## STEREO CONFIGURATION CHANGE REQUEST

For Office Use Only	TITLE:	CLASS:	NUMBER:	
		I II	DATE:	
CONFIGURED ITEM:		ORIGINATOR:		PRIORITY:
STS Number:	Payload: <b>STEREO</b>	Name:	<b>Dave Curtis</b>	<input checked="" type="checkbox"/> Routine
Component :	Experiment: <b>IMPACT</b>	Organization:	<b>U.C. Berkeley</b>	<input type="checkbox"/> Urgent
Component Part #:	Serial #:	Phone:	<b>510-642-5998</b>	<input type="checkbox"/> Emergency
		Email:	<b>dwc@ssl.berkeley.edu</b>	
TYPE OF REQUEST:		RESPONSIBLE ORGANIZATION/INDIVIDUAL:		IMPACTS: (If yes attach additional pages)
<input type="checkbox"/>	Configuration			COST: <input type="checkbox"/> Yes <input checked="" type="checkbox"/> No
<input type="checkbox"/>	Deviation #			SCHEDULE: <input type="checkbox"/> Yes <input checked="" type="checkbox"/> No
<input checked="" type="checkbox"/>	Waiver #			
<input type="checkbox"/>	Other:			
REASONS FOR CHANGE:			RETEST REQUIRED:	
<input checked="" type="checkbox"/>	Improvement	<input type="checkbox"/> Test/Payload Failure	<input type="checkbox"/> New Document:	<input type="checkbox"/> No

<b>STEREO IMPACT</b>		
Title		
STE Door Actuators		
Size	Document Number	Rev
A	<Doc>	A
Date:	Monday, April 29, 2002	Sheet 1 of 1

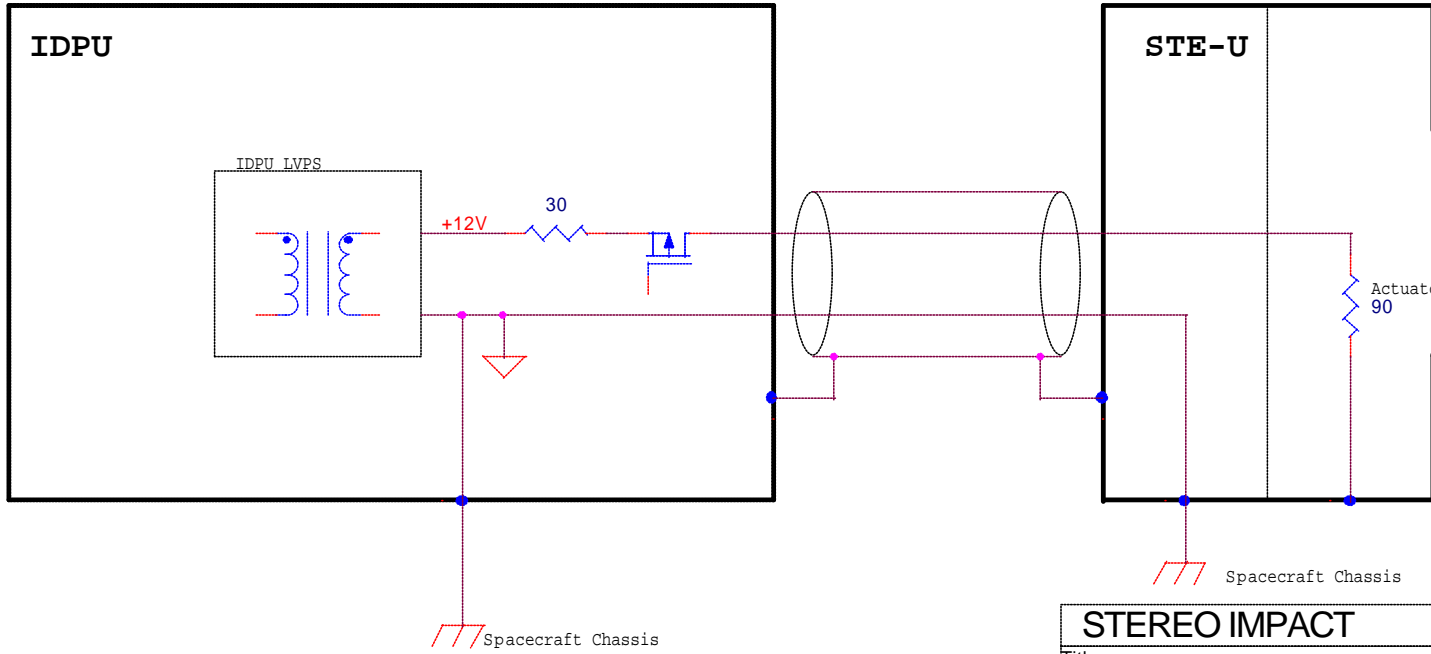
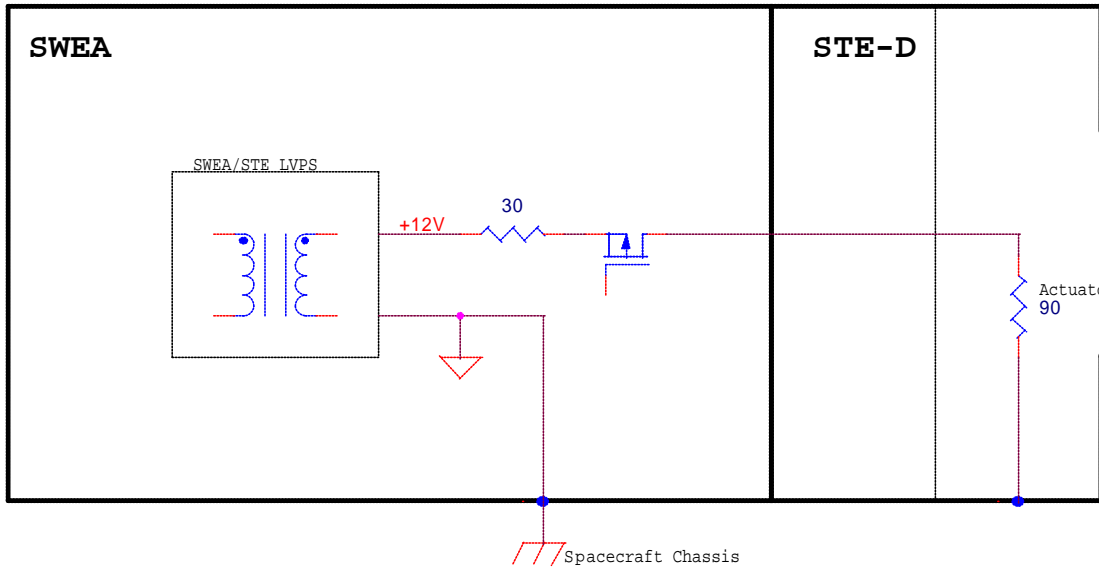
<input type="checkbox"/>	Reliability	<input type="checkbox"/> Specification Requirements	<input type="checkbox"/> Other:	<input type="checkbox"/> Yes
PROPOSED CHANGE (Attach additional pages as required):				
<p>The STE door actuators are not shielded, violating project EMC requirements as called out in 7381-9030-, section 3.1.1. Also the STE-U door return current returns to the IDPU possibly via the spacecraft chassis, violating project EMC requirements as called out in 7381-9030-, section 3.1.2. See attached schematic.</p>				
RATIONALE (Attach additional pages as required):				
<p>The STE door actuators are exposed to space and cannot be easily shielded. To avoid exposing spacecraft power return, these actuators shall be run off secondary power and returned to chassis ground (which is connected to power converter secondary ground). When the actuator is off, it will be at chassis ground with no currents flowing, meeting the EMC requirements. However, when actuated it will expose about 9 Volts and, in the case of STE-U, inject about 100mA into the spacecraft chassis, for about 1 second while the door opens or closes. The door is used to avoid contamination by thrusters or exposure of the detectors to sunlight. The door will be closed for thruster firings, when the instrument is powered off, or when the spacecraft indicates loss of fine sun pointing. These events are infrequent and deterministic, so any noise generated in the MAG or SWAVES instruments should be limited in time, while the amplitude is sufficiently small that other spacecraft systems will not be affected.</p>
